UNITED STATES PATENT AND TRADEMARK OFFICE

APPLICATION NO.	FILING DATE	FIRST NAMED INVENTOR	ATTORNEY DOCKET NO.	CONFIRMATION NO.
10/821,065	04/08/2004	William Gordon	GOR101	9201

Office Action Summary

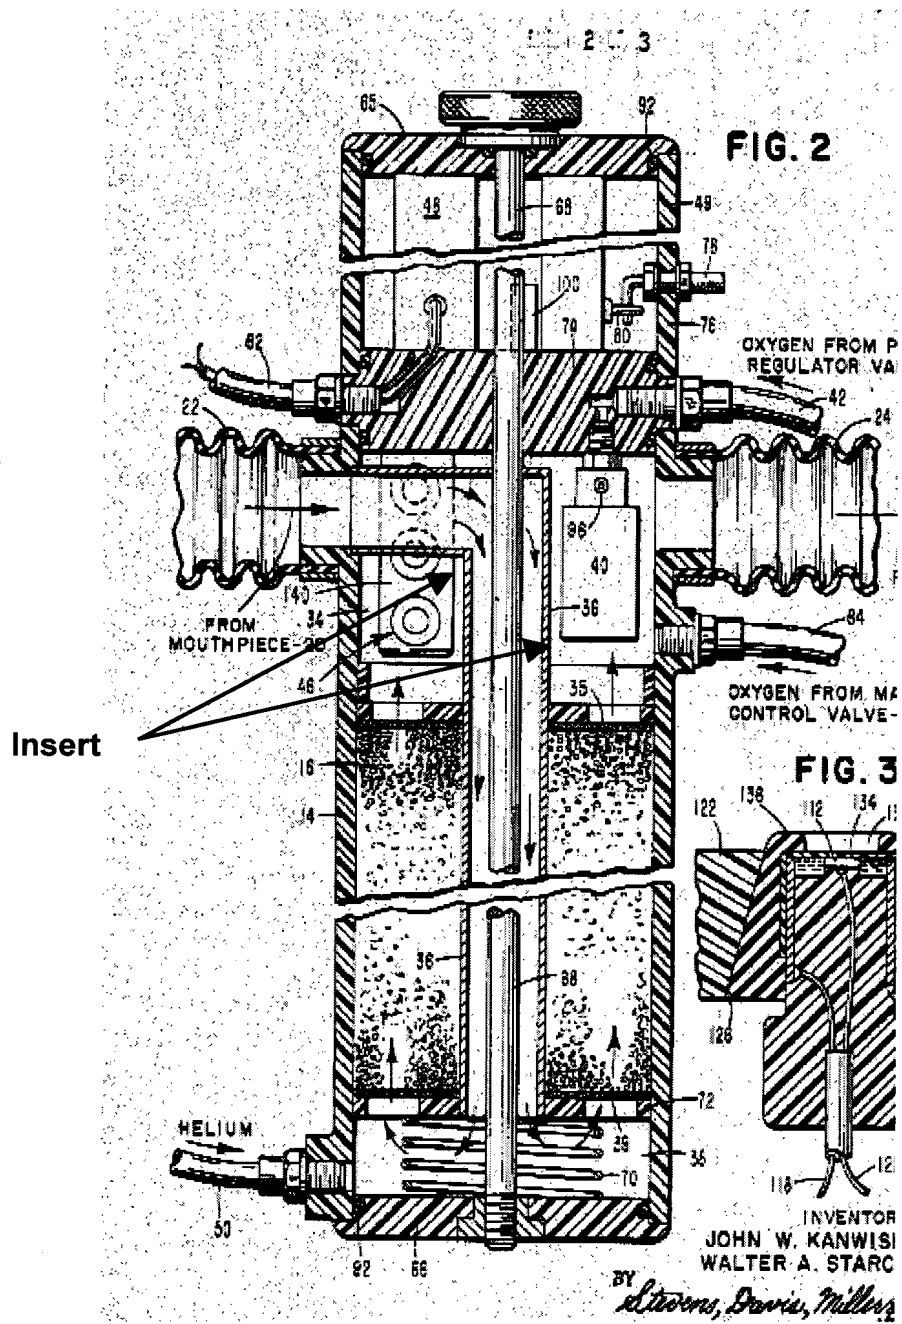
Regarding claim 9, Kanwisher discloses wherein the apparatus is configured such that the gas scrubber canister (14) is worn on a divers back (Fig. 1).

Regarding claim 10, Kanwisher discloses wherein the long axis of the canister (14) is parallel with the long axis of the diver's body (Figs. 1, 2).

Regarding claim 11, Kanwisher is configured such that that gas scrubber canister (14) can be worn on the front of a diver's body (Figs. 1, 2).
